Access Compliance Report Public Rights-of-Way (Curb Ramps)

Main Street: AIROSO_ST Cross Street: ARADA_ST Location: NW

ADA ID: RPAT211104113356 Ramp Type: Type 4 - Parallel Initial Pass/Fail: Fail Overall Compliance: No Severity Score: 30

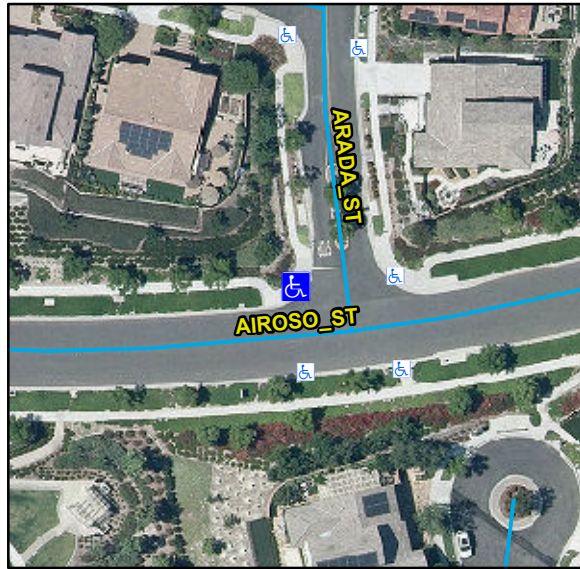
Compliance	Description	Data	Compliance	Description	Data
N/A	Ramp Length LT (in)	91	N/A	Ramp Length RT (in)	75
Yes	Ramp Width LT (in)	92	Yes	Ramp Width RT (in)	93
No	Ramp Run Slope LT (%)	9.5	No	Ramp Run Slope RT (%)	16.5
Yes	Ramp Cross Slope LT (%)	1.3	Yes	Ramp Cross Slope RT (%)	1.5
N/A	Landing Present	N/A	N/A	DWS Provided	N/A
N/A	Landing Length (in)	N/A	N/A	DWS Contrast	N/A
N/A	Landing Width (in)	N/A	N/A	DWS Length (in)	N/A
N/A	Landing Run Slope (%)	N/A	N/A	DWS Full Width	N/A
N/A	Landing Cross Slope (%)	N/A		DWS Offset Type	N/A
N/A	Landing Movement Obstructed?	N/A	N/A	DWS Offset Left (in)	N/A
	Landing Movement Type	N/A	N/A	DWS Offset Right (in)	N/A
N/A	Landing Shared	N/A			
N/A	Clear Space	Yes			
N/A	Clear Space To Crosswalk (in)	N/A			
N/A	Marked Crosswalk 1	No	N/A	Marked Crosswalk 2	No
	Crossing 1 Direction	S		Crossing 2 Direction	E
	Marked Crosswalk 1 Width (in)	N/A		Marked Crosswalk 2 Width (in)	N/A

Remove & Replace Curb Ramp With Two New Directional Ramps or Equivalent.
